Report for an application for resource consents under the Resource Management Act 1991

Application numbers: BUN60393007 (Council Reference)
LUC60393008 (s9 land use consent)
SUB60393009 (s11 subdivision consent)
WAT60407691 (s14 water permit)
DIS60393060 (s15 discharge permit)

Applicant: NORTHWEST DEVELOPMENTS LIMITED

Site address: 18 Scott Road Hobsonville 0618

Figure 1. The proposed development and Roa Avenue extension as shown in BUN6030642 (indicative only)

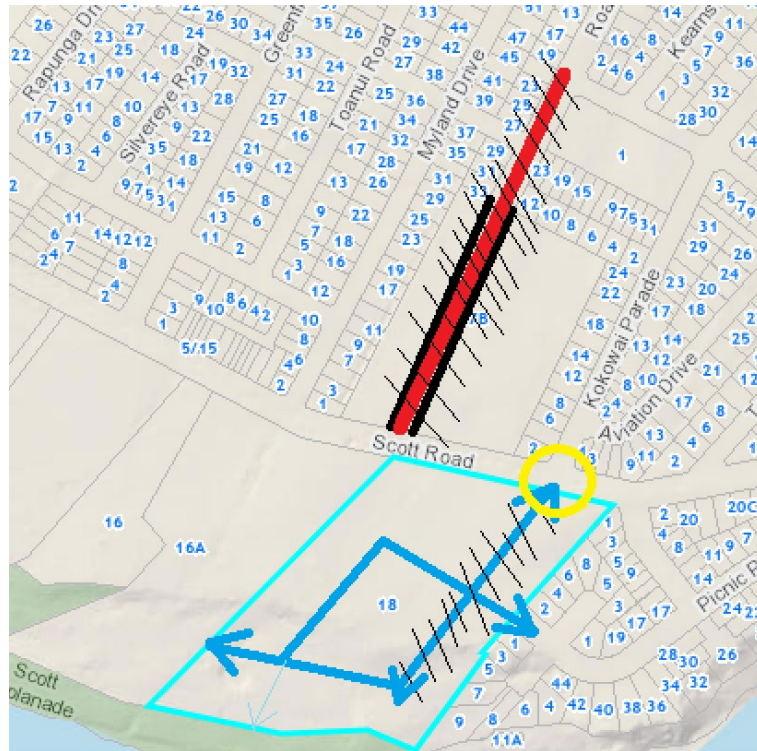
Although the AEE noted that the proposal is consistent with the Precinct Plans, I disagree with this because the proposed vertical local road continues Kokowai Parade (Local Road – 16m width), whereas the “Local Road shown in the Precinct Plan is to continue Roa Avenue

(Secondary Road - 20m width). Although I note the wording “flexible location” and this has already been somewhat compromised by the Framework Plan at 17B Scott Road under BUN60306421 as Road Avenue finishes opposite to 16A Scott Road, I do not consider that the proposal is consistent with the Framework Plan, as shown in the diagrams below.

The on-street communal pocket park, where the proposed bus route goes through, will not be created as Roa Avenue and the proposed road do not intersect. The Precinct Plan shows the local road extends to the esplanade reserve. This had been proposed up to the Suburban Zone boundary and a pedestrian path has been proposed instead. No continuation of the ecological corridor is provided as Roa Avenue and the proposed vertical road do not intersect.

- Given the location of Roa Avenue proposed at 17B Scott Road, it would be challenging for this site to provide the continuation of Roa Avenue down to the southern side of Scott Road, unless a comprehensive development with 16A Scott Road is proposed. This is beyond the scope of this application, and I do not wish to comment further. Whether this road is going to be continued through 16A Scott Road is unknown, and this shall be assessed at its own consenting process. At this stage, I am comfortable with the current site layout, even though this is not entirely consistent with the Framework plan. I consider the applicant appropriately responded to the fixed location of Roa Avenue for the following reasons:

- The proposal will create a small on-street pocket park on their side, which will integrate with the existing Kokowai Parade intersection. The on-street pocket park will be appropriately designed as the applicant offered a consent condition to provide detailed design at an engineering plan approval stage.

- Similarly, the applicant has provided the required ecological corridor on their side. The Council's landscape architect and Parks planner have reviewed the application and have not raised any issues with regard to the proposed landscaping. Although there will be no sense of continuation, the proposal instead extends this road horizontally, connecting east to west. A well-landscaped pedestrian path that connects the site and the neighbourhood to the existing esplanade reserve will also be provided, as confirmed by the Council's landscape architect. This will provide a long ecological corridor throughout the site to the existing esplanade.

- There will be less than minor adverse effects walkability of the neighbourhood. The proposed roading layout still adequately connects north to south and east to west. The above-mentioned pedestrian path will further extend the vertical connection to the esplanade reserve. I consider this is acceptable, given the Precinct's emphasis on walking and cycling connections.
